Summary of Items Discussed in 3/2017 APSEC Discussion Forum on 19 May 2017

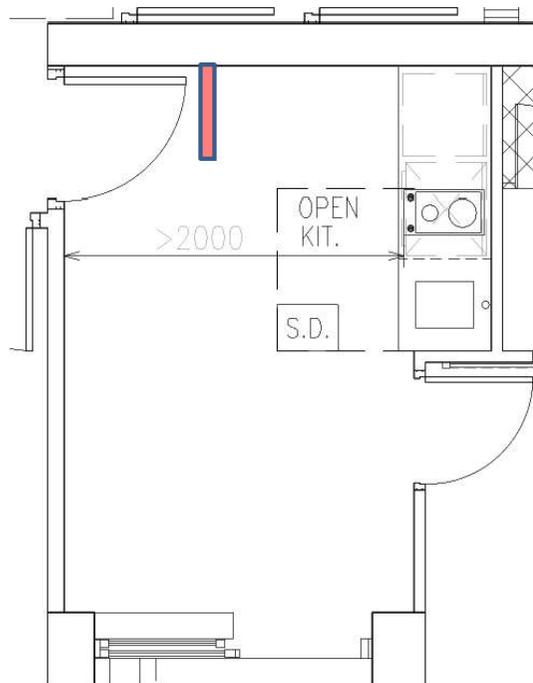
As pointed out in item 7 of 1/2016 ADF, the minimum distance for a sprinkler controlled household stove fire without shielding by walls should be 2m measured from the nearest corner of the stove to the door knob when the exit door was in closed position. In this connection, we have the following 2 queries regarding the diagram attached below

(1) Is the fire rated wall (highlighted in red) required if the cooking appliance is more than 2m away from the flat entrance. (Note: this is a

<p>one-bed room flat.)</p> <p>(2) Is gas stove allowed if it is more than 2m away from the entrance without the fire rated wall.</p>	<p>the stove was located on the screened side from the entrance a layout already serving the screening function for the stove, such walls might not be necessary. On the other hand, in some apparently code-compliant layouts such as the proposed one, since the room was very small and the screen wall could only shadow a part of the exit door, the AP should consider enhancement measures such as safer stoves, on top of the screen wall.</p>
<p>14.</p>	<p><u>Basement Carpark to Estate type Houses Development</u> (Item raised by BD) BD would further elaborate the discussion in Item 6 of 2/2017 ADF for house-type development with basement private carpark spaces.</p>	<p>BD expressed that the industry had all along been reflecting that basement carparks would entail significant construction cost and time as well as being environmentally unfriendly. In the context of aboveground carparks for low rise buildings could be disregarded from accountable GFA, BD reiterated that house type developments providing underground carparks with excessive undesignated space and significant enclosure walls prone to attract misuse or even conversion creating additional fire risks, could hardly be justified. To minimize the extent of excavation for less disturbance to the natural terrain and for assuring fire safety, in basement carparks with open designs, undesignated space around carparks should be kept to minimum necessary. For those enclosed designs which had been justified as necessary, undesignated space around such carparks should not be provided. Creating “inaccessible voids even with bracing” prone to abuse would be undesirable and critically examined.</p>

According to the FS Code 2011, if a fire barrier was not provided in accordance with Clause C13.3, for kitchens **adjacent** to the sole exit of a unit, a full height wall having an FRR not less than -/30/30 and not less than 600mm wide should be provided adjacent to the flat exit door together with the FSIs according to Clause C13.4.

As discussed in item 7 of 1/2016 ADF, where stoves were already provided at location near to exits where screen walls could not be effective to protect the occupants at the entrance or the risk of open flame being likely to injure users of narrow passages, improvements measures should be considered such as the use of stove with extra safety provisions.

From the sketch, the studio flat itself resembled a kitchen of a medium size flat. The “adjacent” meaning is obviously applicable thus requiring the screen wall. Furthermore, the screen wall as shown could obviously serve to a certain extent the screening effect, though not entirely satisfactory. After occupation, the room would likely be very congested with furniture items cornering users close to the stove before reaching exits. The screen wall should be indispensable in this scenario.

Generally speaking, in considering whether screen walls would be required for open kitchens in such small studio flats, BD would pragmatically consider the layout of the flat, e.g. in L-shaped flats where
